CARMICHAEL-KEMP, ARCHITECTS

MEETING NOTES

TO:	PASADENA UNIFIED SCHOOL DISTRICT 740 West Woodbury Road Pasadena, CA 91103	PROJECT: WILLARD ELEMENTARY MODERNIZATION PROJECT
		MEETING TYPE: Meeting with Site Council
		MEETING DATE: September 10, 2010
ATTN:	MR. STEVE BRINKMAN	PREPARED BY: LARRY BUTKUS
THOSE PRESENT:	Debra De Bose (Principal) Site Council: See attached list.	
	Renatta Cooper (Board Member)	
	Steve Brinkman (District Chief of Facilities) sbrinkman@pusd.us	
	Gerald Schober (District Facilities) gschober@pusd.us	
	Eric Nelson (Early Childhood Consultant to District) cec@cco.caltech.edu	
Tammy Schaeffer (architect) tammy@ckarch.net

- 1.01 At the direction of the Facilities Subcommittee, review proposed change in design to accommodate recommendations of Eric Nelson relative to early childhood development concepts.

OPTION #2

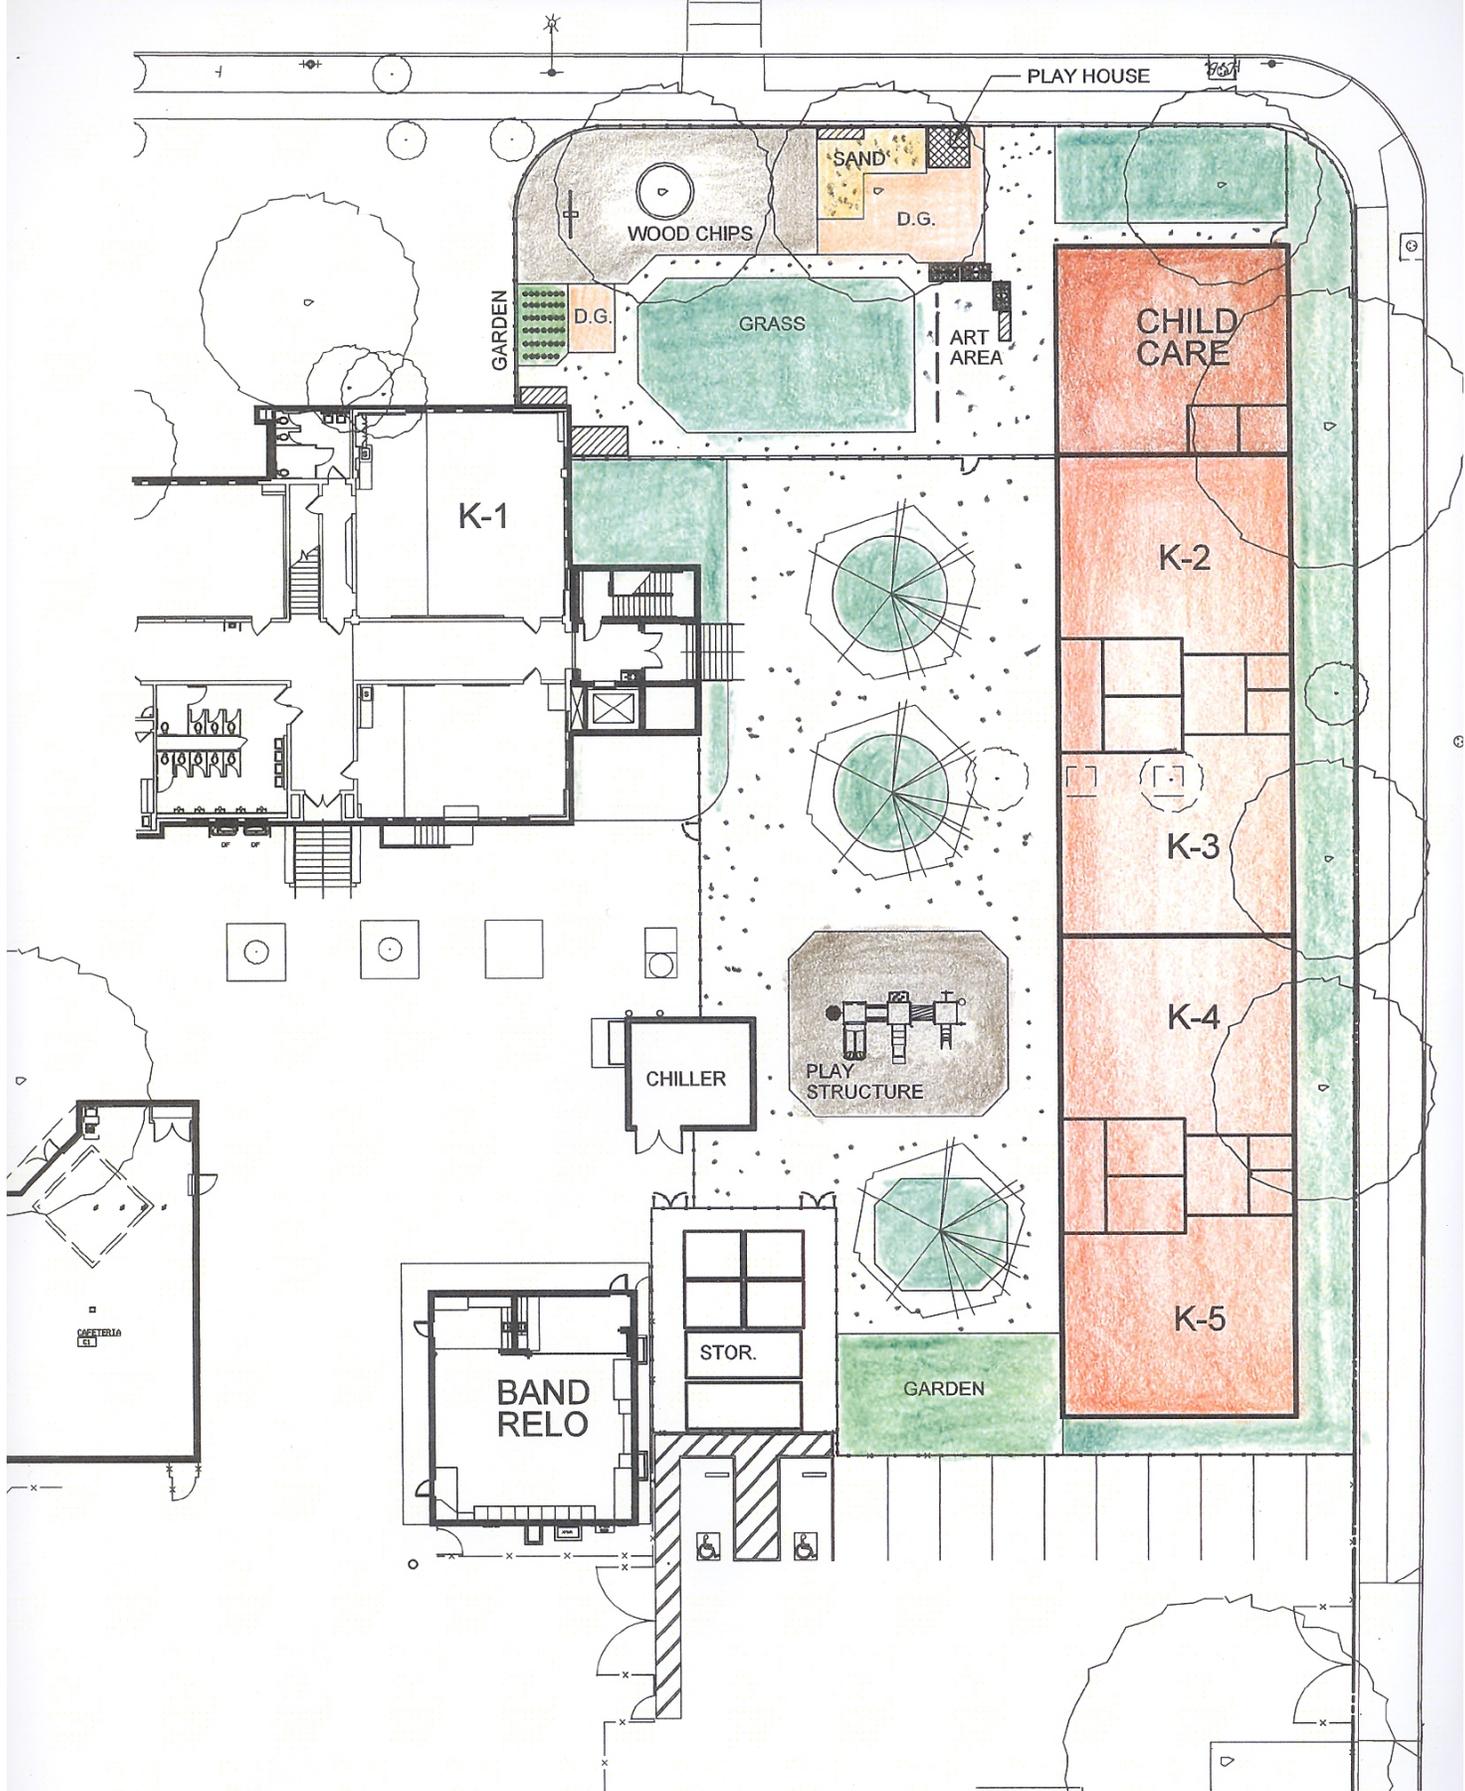
- 3.02 The following comments were made by some of the teachers:
- A connection between the Kindergarten building and the main school is felt to be very important from the parents point of view – the Kindergartens are a transition into elementary school and the facilities need to reinforce that transition and connection.

- A physical connection, a covered walkway or path of travel from the new kindergarten complex to the existing building is important for rainy days.
 - Child care and Kindergarten need to have separate playgrounds (both current and proposed design support separate playgrounds or yard areas).

- The size of the Kindergarten yard is very important, as up to 125 children might be utilizing the yard at one time (5 kindergarten classes). While morning recesses are staggered, the use of the yard at lunch time is not. The teachers expressed concern that the revised design does not allow adequate space for swings and play structures, which are very important.

- 3.03 Eric Nelson asked for the teachers to accept the premise that the yard configuration could be such that it did provide the required swing and play apparatus components, along with other features. If this was the case, Eric questioned if the teachers were supportive of the revised building configuration (one long building, classrooms all in a row, each having direct access to the yard area).

- There was still the concern that there would need to be a covered walkway between the existing building and the new building. Tammy indicated a covered walkway could be added, or perhaps even an outdoor shelter could provide the covered connection while also providing the needed outdoor covered play/activity area.

- There was some discussion as to whether or not it would be too noisy and distracting to have windows between the classrooms and the kindergarten yard – however, some teachers indicated that they currently teach in classrooms that face the playground and do not find it distracting or noisy.

- 3.04 Tammy stated that it seemed that if the yard design could incorporate the required play equipment and swings, then the teachers were in agreement that the new building layout would be fine. She suggested that she look at the new building layout in more detail, making the required modifications to the toilet access, prep room, etc, required so that the prior room layout/configuration now makes sense relative to the new site location and orientation. After she has done that, then perhaps Eric can work on the design of the yard to incorporate the input provided today at this meeting, and the revised building and yard

designs can then be brought back to this committee for review once again, prior to reporting back to the Facilities Subcommittee.
